3021615

3219 CLAREMONT AVE S | SEATTLE WA 98144

ADMINISTRATIVE DESIGN REVIEW - RECOMMENDATION

# Staff supports the simplified massing form of preferred Option 3 ... i. Create greater legibility of the entry... / iii. Strengthen the visual connection and tie to the courtyard space.

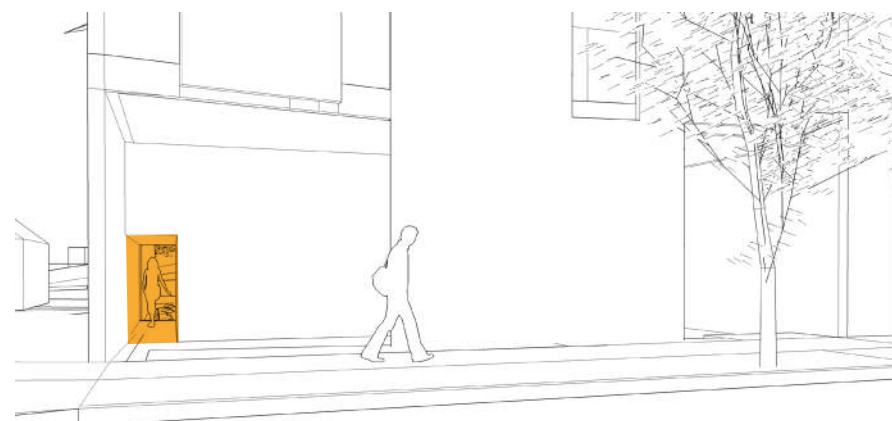
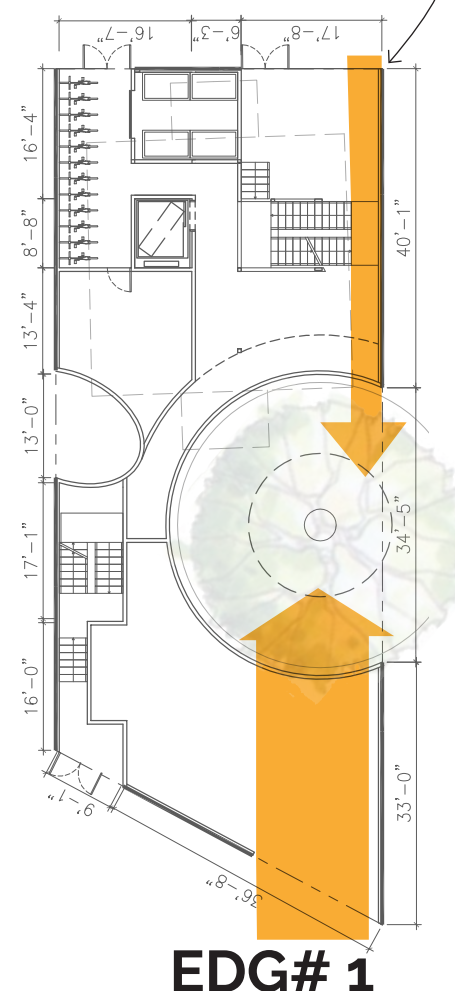
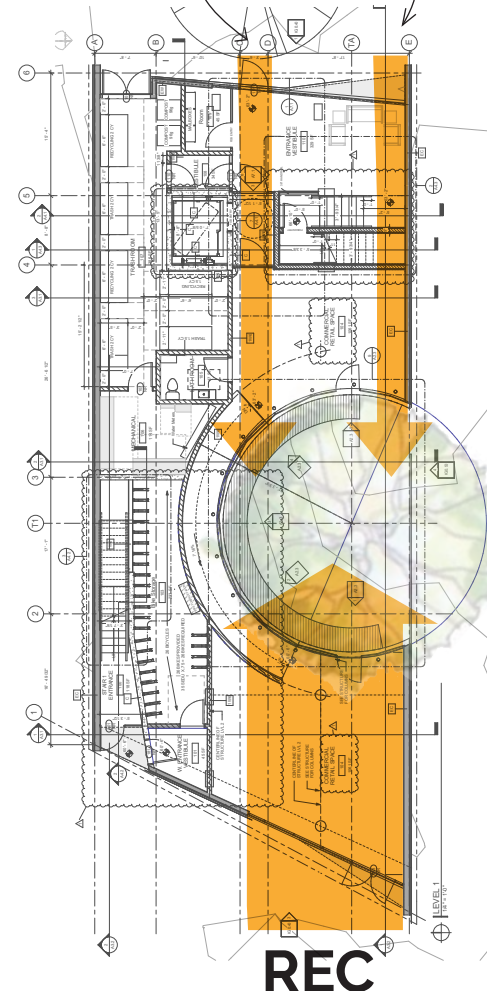
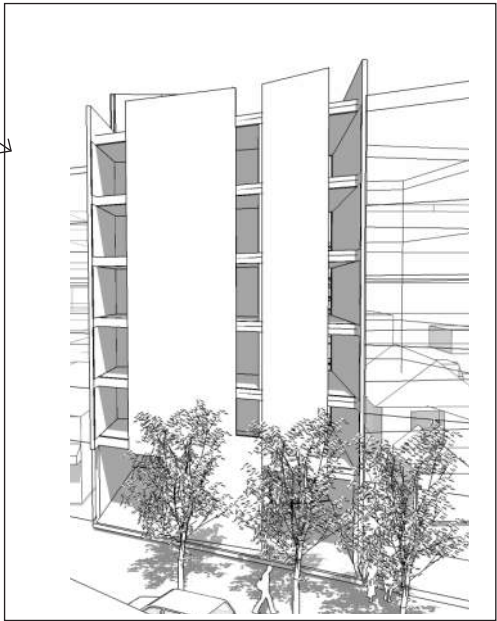
b. Staff supports the concept of emphasizing the slender massing form with long ribbons of textured high-quality materials as shown on page 30 of the EDG packet. The next iteration should further:

i. Create greater legibility of the entry. PL3-A Entries

iii. Strengthen the visual connection and tie to the courtyard space. DC3-A-1. Interior/Exterior Fit, DC1-A-4. Views and Connections

The existing visual connection to the courtyard from Claremont Ave was maintained while also adding another view into the courtyard through a glazed elevator lobby.

The visual connection to the courtyard from MLK Way was widened to further tie the activity of the street and commercial space into the activity of the courtyard.

West Wall

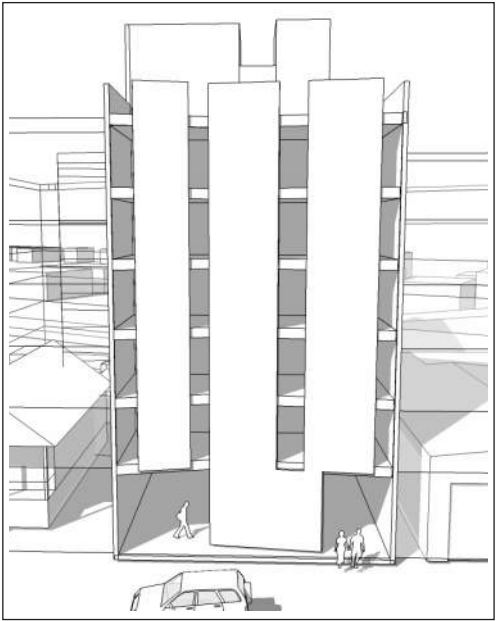
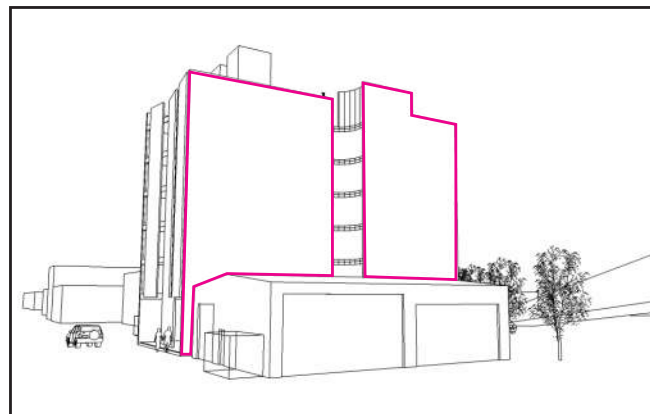
ii. Integrate horizontal breaks on the east and west facades as shown in precedent images on page 30 of the EDG packet with the goal of creating visual interest, playful façade articulation which distinguishes the building as residential rather than industrial, and incorporates changes in depth along the street facing facades. DC2-B-1. Façade Composition, DC2-C-1. Visual Depth and Interest

Horizontal Breaks were added to the east and west facades - similar to those shown in the precedent image (left). Additionally, to create a uniform facade these horizontal breaks were carried along the north and south facades.

The fenestration along the east and west walls was divided and arranged in a manner similar to other residential projects to help differentiate it from industrial buildings. There will be a collection of both fixed and operable windows to add variation to the facade.

Vertical Box Rib Siding

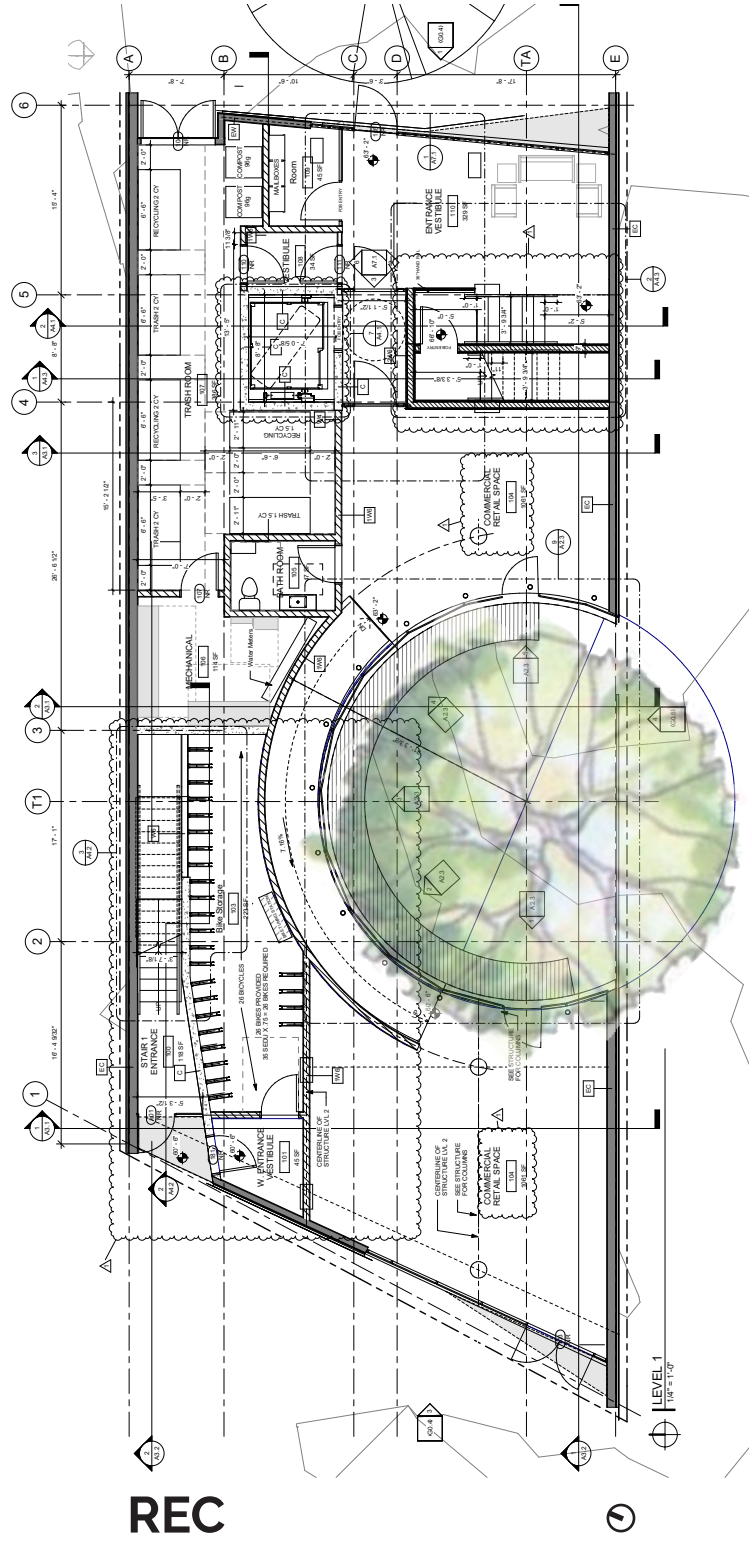
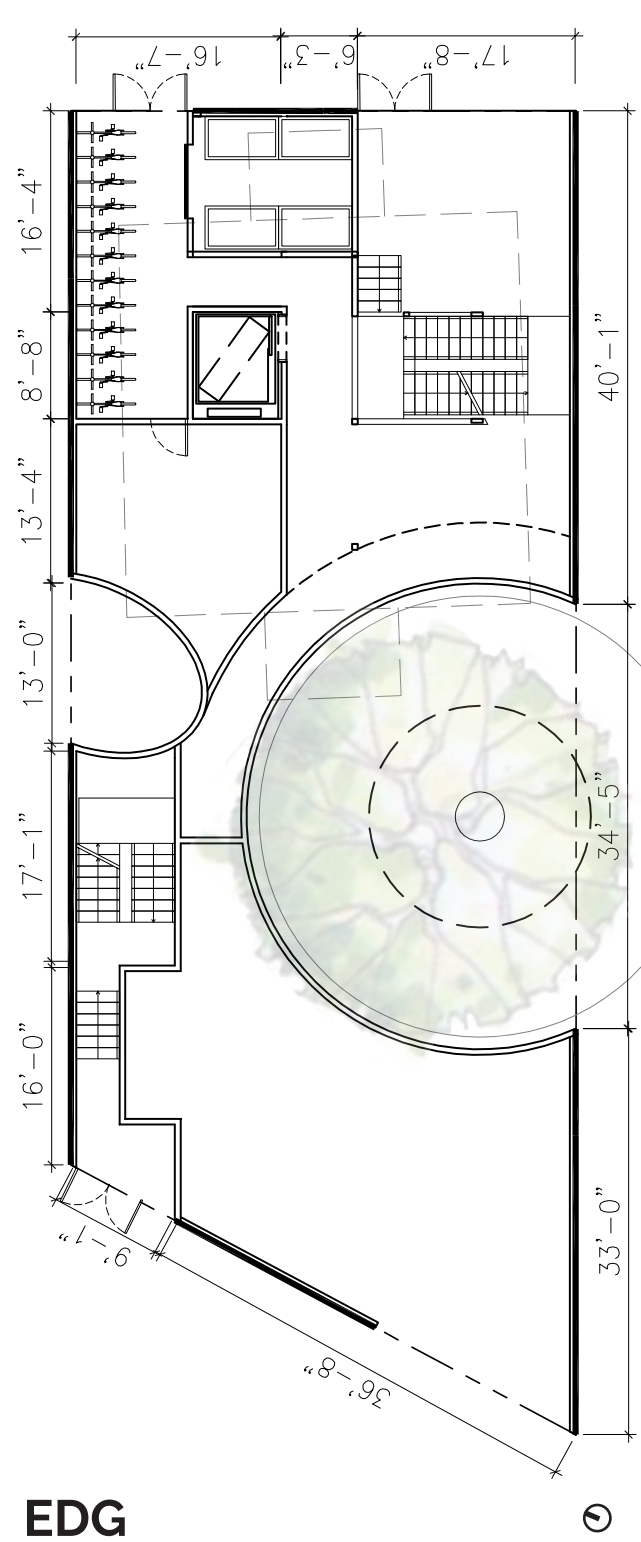
a. Staff supports of the indicated material palette including textured metal siding, panels with varying translucency, and glass. DC2-D Scale and Texture, DC4-A Exterior Elements and Finishes

b. Staff is supportive of the conceptual images presented on page 30 of the EDG packet regarding the blank wall condition, however strongly encourages some plane changes along these facades with the goal of creating a more seamless transition from the east and west facades to the sides. The north and south facades are highly visible and the articulation of the blank walls should reflect a cohesive and seamless transition from street-facing facades. DC2-B-2. Blank Walls

The material palette presented at EDG has been maintained with the usage of a highly textured metal siding. See page 31 for more information.

The north and south facades were designed with similar vertical and horizontal alignments with the east and west facades as well as the usage of a consistent box-rib material. However to set the N/S sides apart from the E/W sides a change in color helps to differentiate the volumes.

The windows along the E/W facades are set in slightly from the metal cladding and the N/S courtyard recesses help create a more varied and playful facade.

RESPONSE TO EARLY DESIGN GUIDANCE - TREE PROTECTION / SUCCESSION PLANS

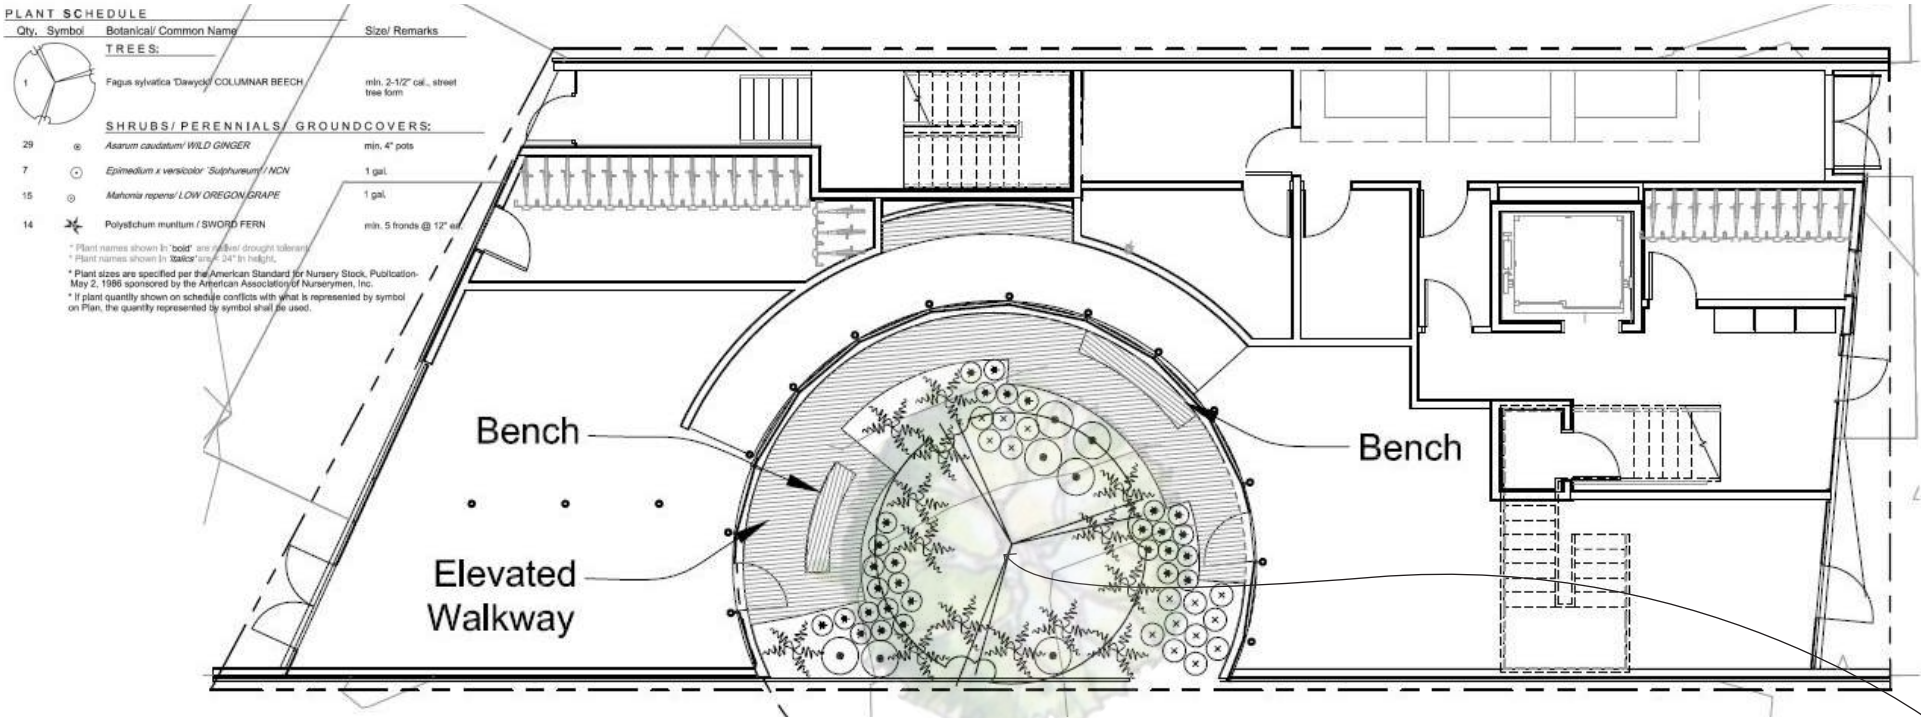
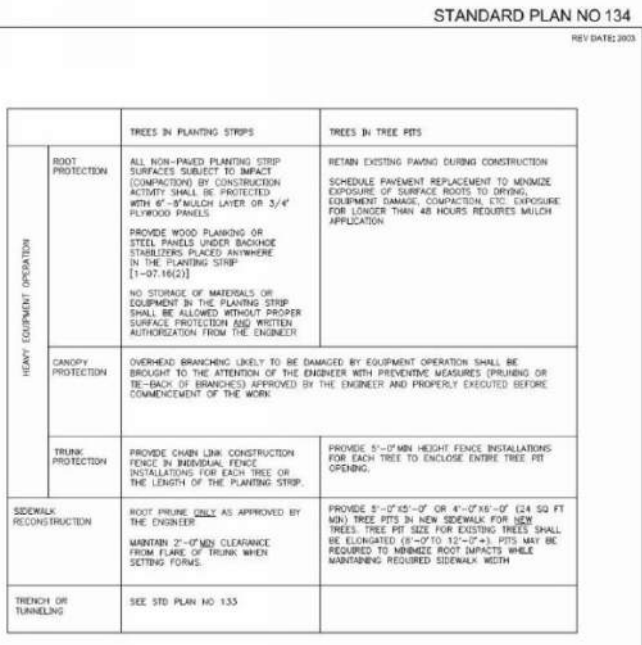
- 2. Landscaping/Courtyard:
  - a. Staff is highly supportive of the preservation of the exceptional tree. Provide on the viability of the existing sequoia within the courtyard. DC4-D-4. Place Making, DC4-D- 3. Long Range Planning
  - b. Provide a succession or replacement plan of the tree should the exceptional tree be damaged during construction. DC4-D-3. Long Range Planning

The existing Sequoia tree has been surveyed by Robert Williams, Arborist, and closely measured in terms of its dripline and overall health. The design of the courtyard as both finished project and the process of construction has taken into account the needs of the tree to ensure its survival - See protection standards, which will be included in the approved plan set.

Furthermore, in the event that the tree would need to be replaced a succession plan has been drawn by Glenn Takagi, Landscape Architect - see page 25.

In response to the tree life span expectancy after construction, possible succession plan to replace the tree, (should the tree deteriorate):
